Appln. No. 10/827,343
Amdt. dated March 8, 2006
Reply to Office Action of November 8, 2005

Amendments to the Drawings

FIG.6

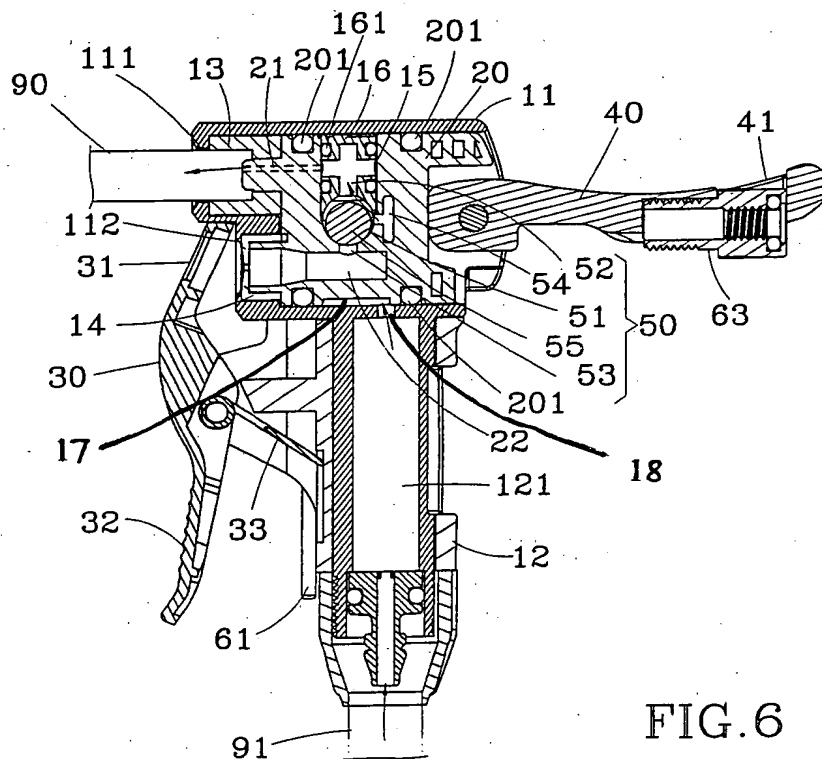
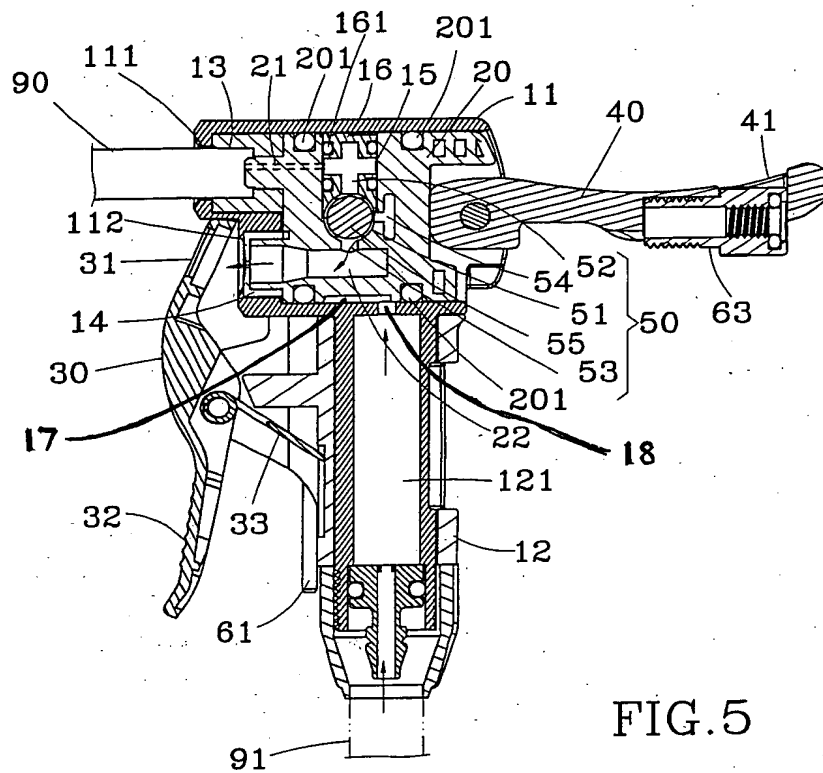
In response to the rejection of claim 1 under 35 U.S.C. §112, first paragraph, Applicant has amended the specification and the drawings to describe and show "interstice 17" and "admitting hole 18" which serve to connect the air flows from the air inlet (121) through the casing body

(12) to interact with the switch valve (50) to exit out of the casing head (11) through the first and second holes (111 and 112). Fig. 6 of the application clearly shows an arrow showing the movement of air from air inlet 121 through admitting hole 18 into interstice 17 where it then travels to exit out of casing head 11. Applicant submits that interstice 17 and admitting hole 18 are not inventive features of the claimed invention, as both are prior art clearly taught by interstice 19 and admitting hole 11 of U.S. Patent 5,960,815 to Applicant.

The attached sheet of drawings includes changes to Fig. 5-6. This sheet, which includes Figs. 5 and 6, replaces the original sheet including Figs. 5-6. In Figs. 5-6, previously omitted elements 17 and 18 have been added.
